Engineering Referral Response

Application Number:	DA2024/1362
Proposed Development:	Demolition works and construction of mixed use hospitality venue with supporting car parking, servicing and landscaping works
Date:	27/05/2025
To:	Claire Ryan
Land to be developed (Address):	Lot 180 DP 752017 , 40 Myoora Road TERREY HILLS NSW 2084

Development Engineering 2nd Referral Comments.

Council's Indicative Drainage Infrastructures Location

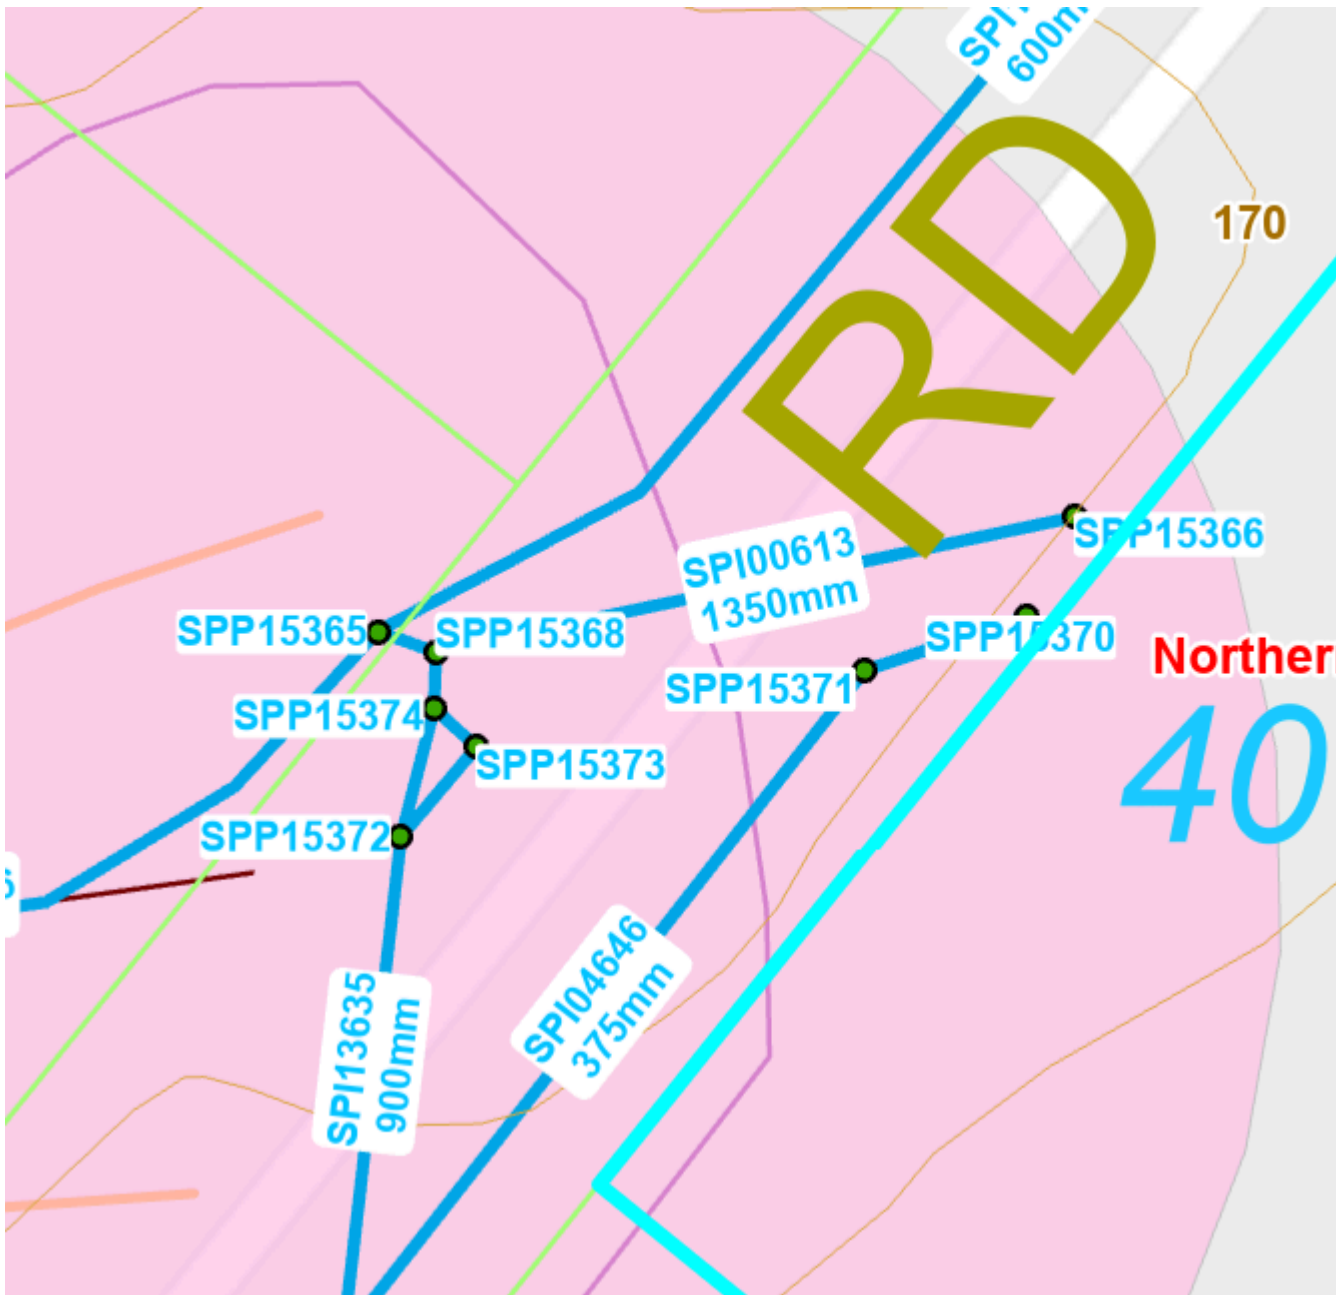
- According to Council's records, a Council's stormwater lintel pit connects to a 1350mm Council's channel chamber travelling across the road. Please discharge stormwater runoff from the subject site to this kerb inlet pit which will resolve the surcharge issue from the boundary pit. An indicative location of Council's drainage infrastructures is attached at the end of this referral letter.

- The 1350mm Council's channel chamber shown in Council's system is indicative only. A licensed plumber should investigate and locate this Council's channel chamber to double check its size, and to make sure it crosses Myoora Road and eventually goes to the creek.

- i. The stormwater outlet pipeline from the OSD tank shall be connected to the existing Council's kerb inlet pit rather than connecting to Council's underground channel if feasible.
